MEMORANDUM

SUBJ: Goddard School Amended Plan Waiver of Land Development #26-05

Reference: 820 N. Bethlehem Pike – Goddard School
Land Development Waiver Request – Review 1
TMP Nos. 39-00-00223-00-8

**Subj: 1622 Gypsy Hill Road (Lot 2 of 1616 School House Lane Minor Subdivision Plan)
WAIVER REQUEST
Parcel No. 39-00-03847-01-1
Lower Gwynedd Township, Montgomery County
STA Project #6615**

IMPROVEMENTS PLAN FOR GODDARD SCHOOL
820 N. BETHLEHEM PIKE
SPRING HOUSE, PA 19002
LOWER GWYNEDD TOWNSHIP • MONTGOMERY COUNTY • PA

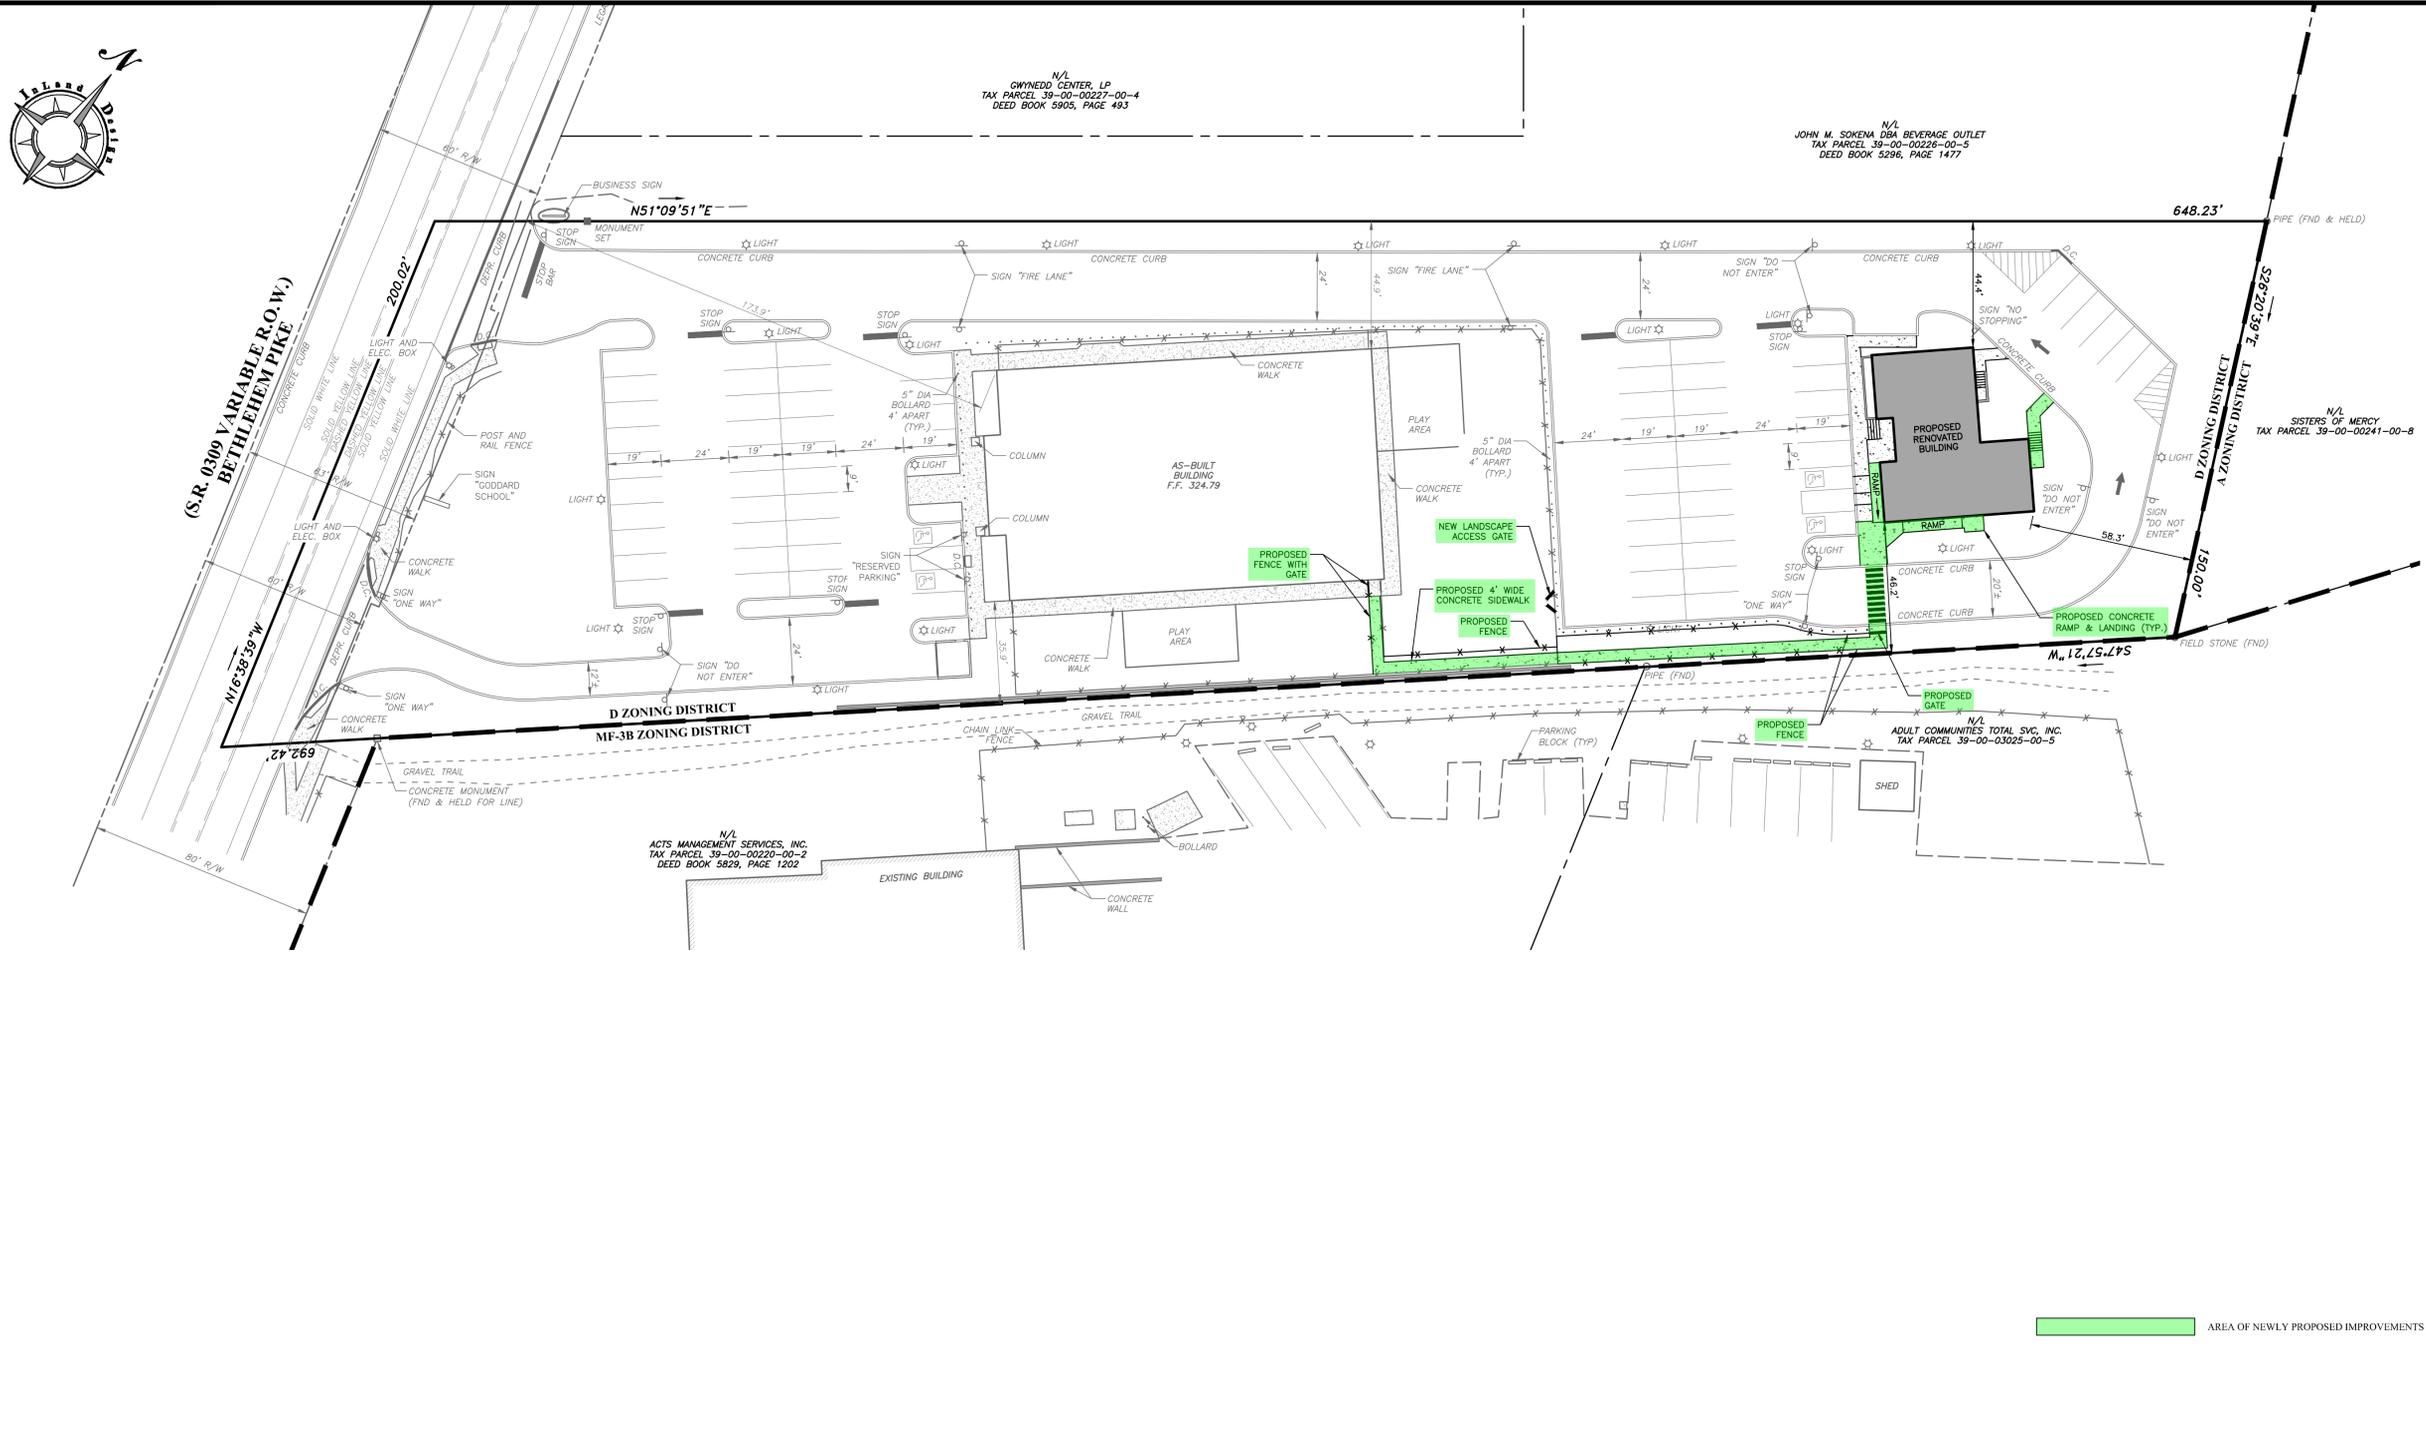
1. We note that the project area is located within Limit of Disturbance of the original Final Land Development Plan. The plan set shall be revised to include the locations of the inlets in the rear parking lot with erosion and sediment controls, which shall include the inlet filters to be installed prior to construction. Details for these E&S controls shall also be provided.

2. Construction details shall be provided for all proposed improvements including the concrete sidewalks, fences, gates, crosswalk, and ramps.
3. The plans shall be revised to include spot elevations and slopes of the proposed ramps located adjacent to the rear building.

5. We note that the area of the proposed sidewalk, along the southeastern property line, contains many trees and plantings as required under the original land development approval. The plans shall be revised to show where these plantings will be installed and/or relocated.

1. An ADA ramp should be shown on the plan at the following locations:
 - In the vicinity of the ADA parking spaces on the western side of the modified daycare building on the eastern end of the site.

- On both sides of the proposed crosswalk located in the one-way drive aisle to the south of the modified daycare building on the eastern end of the site.

2. "Pedestrian Crossing" warning signs with downward arrow plaque should be shown on the plan on both sides of the proposed crosswalk in the one-way drive aisle to the south of the modified daycare building on the eastern end of the site facing the west.

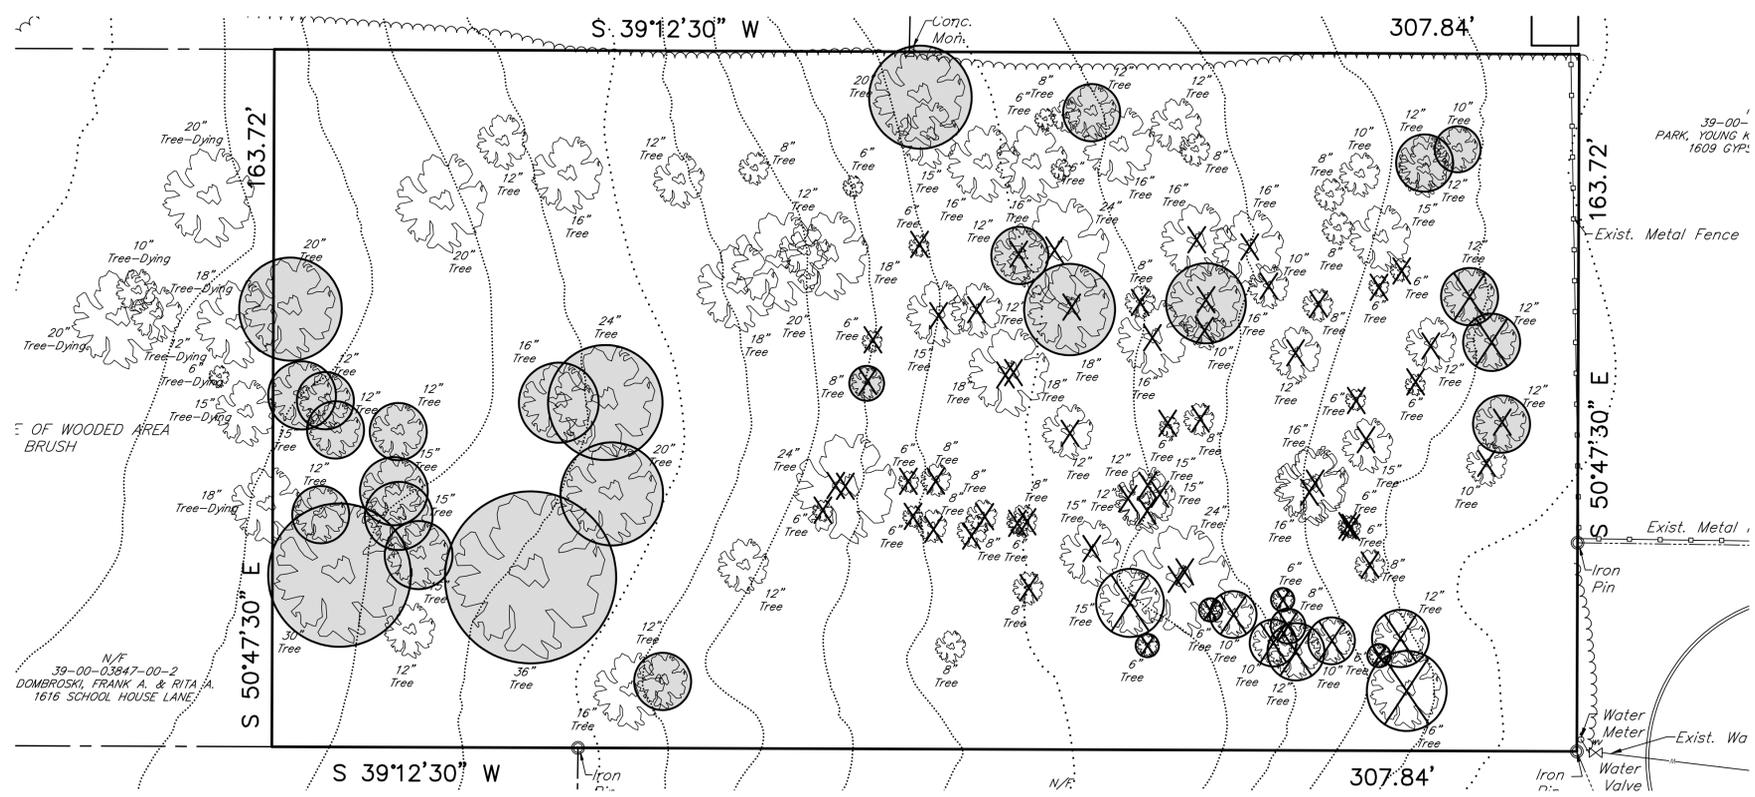
5. Note 2 on the Tree Removal Comparison indicates that 197 caliper inches are proposed to be removed on the 2026 building permit plan, and this quantity is also listed in the waiver request letter. However, the 2026 Replacement Tree Calculations table indicates that 117 caliper inches are proposed to be removed. The Applicant shall clarify the caliper inches to be removed for the 2026 Building permit plan, so that the total tree removal and replacement can be quantified.

STANDARD CONSTRUCTION DETAIL #3-4 STOCKPILE CONTROL

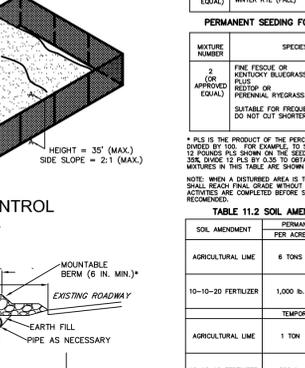
10. The detail of the stockpile control is inconsistent with the depiction on the E&S plans. The applicant shall revise the detail, construction sequence notes, and/or detail for consistency. A detail for silt fence shall be provided if applicable.
